Access Compliance Report Public Rights-of-Way (Curb Ramps)

Main Street: PATINA_LN Cross Street: LODEN_PASS Location: NW

ADA ID: RPRK211104131750 Ramp Type: Type 4 - Parallel Initial Pass/Fail: Fail Overall Compliance: No Severity Score: 30

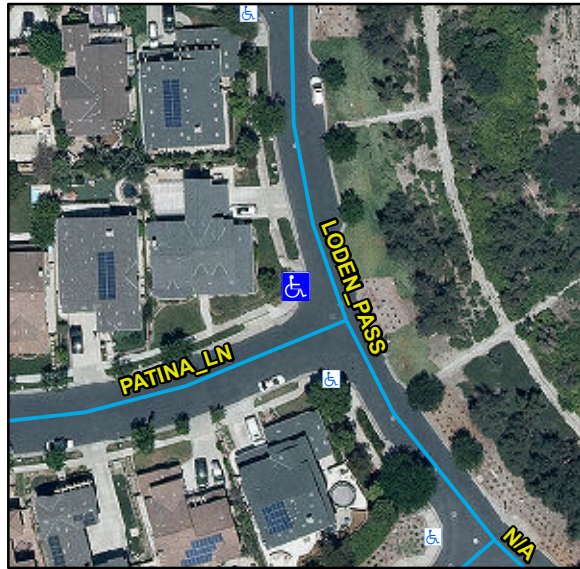
R204.3, R304.5.3, R304.3.2, STD 1115

Compliance	Description	Data	Compliance	Description	Data
N/A	Ramp Length LT (in)	151	N/A	Ramp Length RT (in)	136
Yes	Ramp Width LT (in)	53	Yes	Ramp Width RT (in)	53
Yes	Ramp Run Slope LT (%)	1.1	No	Ramp Run Slope RT (%)	9.1
No	Ramp Cross Slope LT (%)	3.7	No	Ramp Cross Slope RT (%)	5.2
N/A	Landing Present	N/A	N/A	DWS Provided	N/A
N/A	Landing Length (in)	N/A	N/A	DWS Contrast	N/A
N/A	Landing Width (in)	N/A	N/A	DWS Length (in)	N/A
N/A	Landing Run Slope (%)	N/A	N/A	DWS Full Width	N/A
N/A	Landing Cross Slope (%)	N/A		DWS Offset Type	N/A
N/A	Landing Movement Obstructed?	N/A	N/A	DWS Offset Left (in)	N/A
	Landing Movement Type	N/A	N/A	DWS Offset Right (in)	N/A
N/A	Landing Shared	N/A			
N/A	Clear Space	Yes			
N/A	Clear Space To Crosswalk (in)	N/A			
N/A	Marked Crosswalk 1	No	N/A	Marked Crosswalk 2	No
	Crossing 1 Direction	S		Crossing 2 Direction	E
	Marked Crosswalk 1 Width (in)	N/A		Marked Crosswalk 2 Width (in)	N/A

Remove & Replace Curb Ramp With Two New Directional Ramps or Equivalent.
